COMMITTEE/BOARD OF SUPERVISORS

Please accept this Appeal of the Revised Final Mitigated Negative Declaration for 3516 and 3526 Folsom Street, submitted on 3/25/2020

RE: Appeal of CEQA Revised Final Mitigated Negative Declaration Planning Case No. 2013.1383ENV BOS Motion No. M17-152 Building Permit Application Nos. 2013.12.16.4318 and 2013.12.16.4322 3516 and 3526 Folsom Street

Incorrect size of Evacuation Zone *

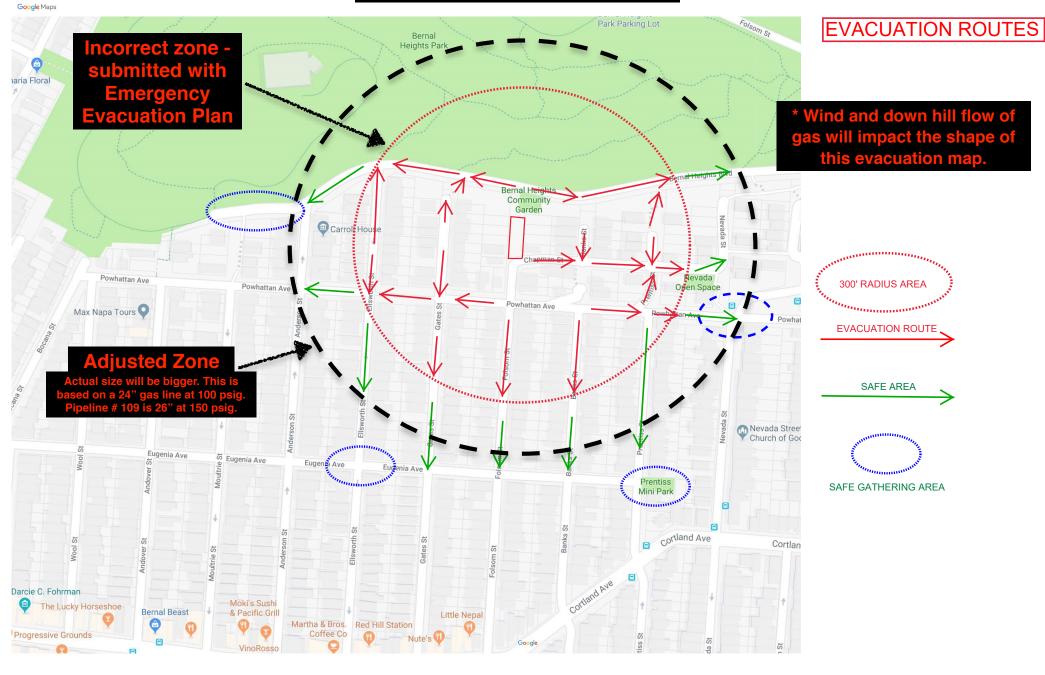
The plan's 300-foot radius of evacuation area map is incorrect. If drawn correctly more residents would be in the evacuation zone - as well as more park visitors. The recommended minimum evacuation distance is 547' for a gas pipeline with a 100 psig for a 24" diameter pipeline, according to PAPA's, *"Recommended Minimum Evacuation for Natural Gas Pipe Line Leaks and Ruptures."*

Bernal Park visitors are left out of evacuation plans - although a substantial part of the evacuation area is in the park, including three heavily used trails. There are no defined safe areas for park visitors. (See attached Evacuation zone diagram.)

Figure 1: Existing Project Site Slope

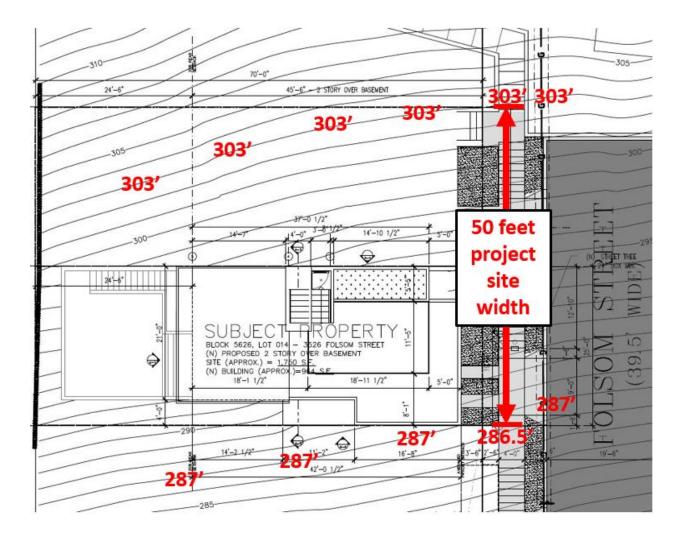
The RFMND describes the slope of the project site as 33 percent on pages ii, 7, and 111, and shows the slope graphically on pages 11, 12, 13, 16, 17 and 20. Generally, the slope of a project site may be calculated from multiple directions, providing different values. The 33 percent slope is an approximation of the slope closest to the eastern edge of the project site, which parallels the slope of the underground PG&E Pipeline 109 and also parallels the proposed extension of Folsom Street.

Figure 1, below, shows how the approximately 33 percent slope of the project site was determined. The project site, which includes the two lots at 3516 and 3526 Folsom Street, has an elevation of approximately 303 feet at the northeastern corner. The elevation at the southeastern corner is approximately 286.5 feet. The width of the project site is 50 feet. Slope is calculated as the ratio of vertical change over horizontal change. As such, 303 feet minus 286.5 feet is 16.5 feet difference in elevation (vertical change), which, when divided by the 50-foot width of the project site (horizontal change) is 0.33, or 33 percent.

Figure 4: PG&E transmission line relative to proposed site plan.

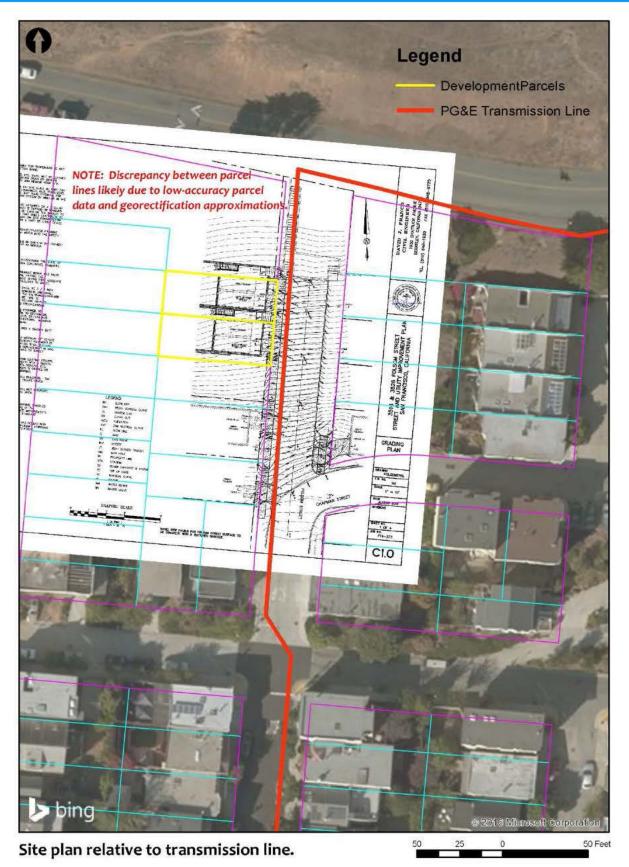
The proposed projects are located immediately adjacent to a major PG&E transmission natural gas pipeline (Figure 1, Figure 2, Figure 3). This major pipeline is located immediately below the primary access road for the construction (Figure 4, Figure 5), immediately adjacent to significant proposed new utility work (e.g. gas service, water supply, sewer) as well as removal of existing pipeline soil cover (Figure 6, Figure 7), and immediately adjacent to significant proposed bedrock excavation (depths on the order of 6 to 10 feet per the submitted architectural elevations (such as sheet A-3), as seen in .
